PROJECT: BLOOMSBURY QUARTER

DRAWING TITLE: SICILIAN ENTRANCE DOOR REFURBISH AND ARCHWAY PANELLING JNR124 GROUND FLOOR

PACE DRAWING Nr: JC2402-00JNR124-01.01
REV Nr: C 02
CLIENT DRAWING Nr: BQ-4450-VSH-00-DR-X-12401

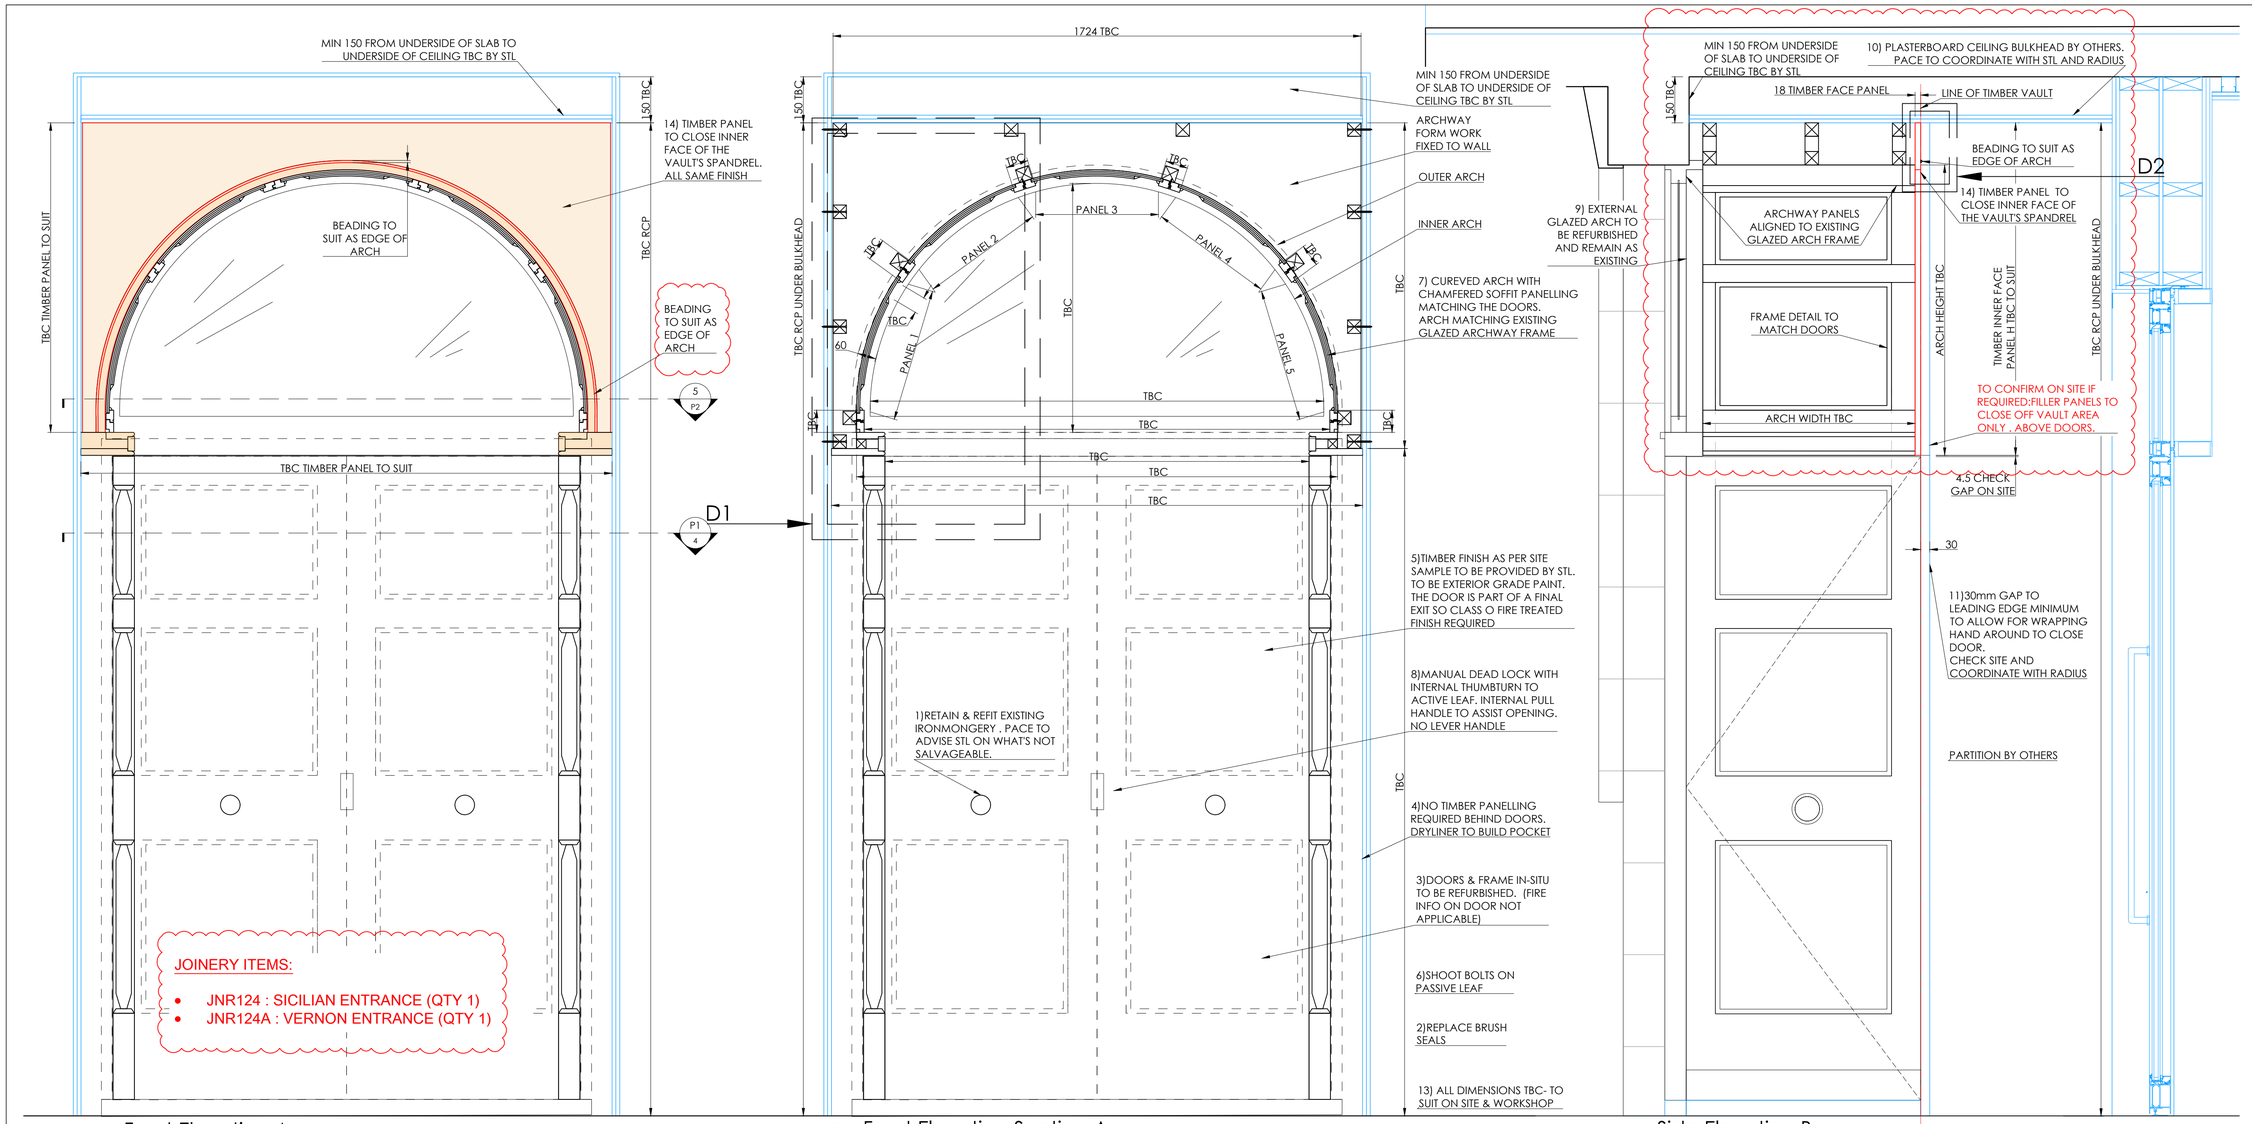
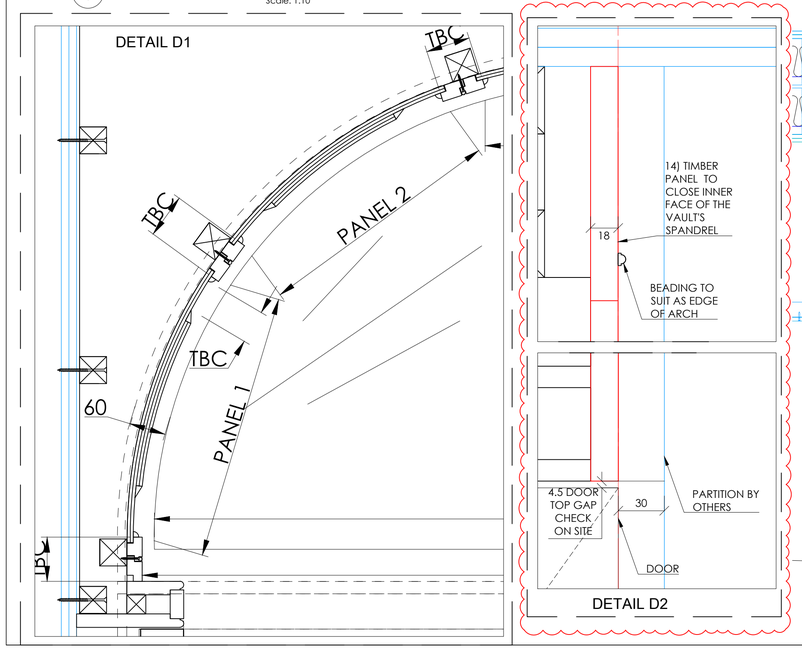
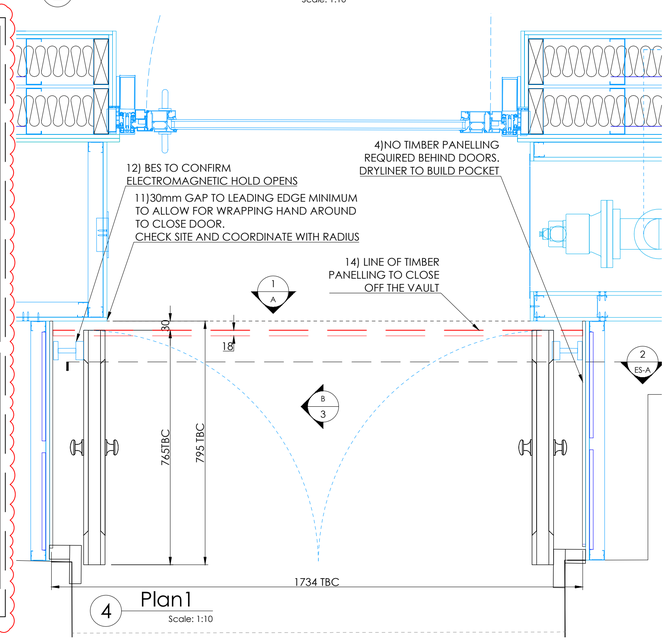
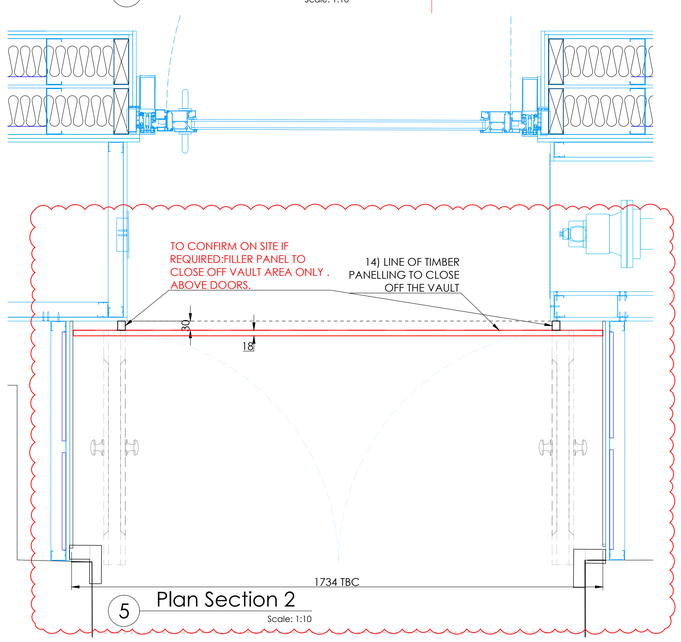
SITE SURVEY REQUIRED-PATTRESS BY OTHERS REQUIRED
NOTES:
1. RETAIN & REFIT EXISTING IRONMONGERY . PACE TO ADVISE STL ON WHAT'S NOT SALVAGEABLE.
2. REPLACE BRUSH SEALS

3. DOORS & FRAME IN-SITU TO BE REFURBISHED. (FIRE INFO ON DOOR NOT APPLICABLE)
4. NO TIMBER PANELLING REQUIRED BEHIND DOORS. DRYLINER TO BUILD POCKET
5. TIMBER FINISH AS PER SITE SAMPLE TO BE PROVIDED BY STL. TO BE EXTERIOR GRADE PAINT. THE DOOR IS PART OF A FINAL EXIT SO CLASS O FIRE TREATED FINISH REQUIRED

6. SHOOT BOLTS ON PASSIVE LEAF
7. CUREVED ARCH WITH CHAMFERED SOFFIT PANELLING MATCHING THE DOORS. ARCH MATCHING EXISTING GLAZED ARCHWAY FRAME
8. MANUAL DEAD LOCK WITH INTERNAL THUMBTURN TO ACTIVE LEAF. INTERNAL PULL HANDLE TO ASSIST OPENING. NO LEVER HANDLE

9. EXTERNAL GLAZED ARCH TO BE REFURBISHED AND REMAIN AS EXISTING
10. PLASTERBOARD CEILING BULKHEAD BY OTHERS. PACE TO COORDINATE WITH STL AND RADIUS
11. 30mm GAP TO LEADING EDGE MINIMUM TO ALLOW FOR WRAPPING HAND AROUND TO CLOSE DOOR. CHECK SITE AND COORDINATE WITH RADIUS

12. BES TO CONFIRM ELECTROMAGNETIC HOLD OPENS
13. ALL DIMENSIONS TBC- TO SUIT ON SITE & WORKSHOP
14. TIMBER PANEL REQUIRED TO INNER FACE OF THE VAULT'S SPANDREL. ALL IN THE SAME TIMBER FINISH
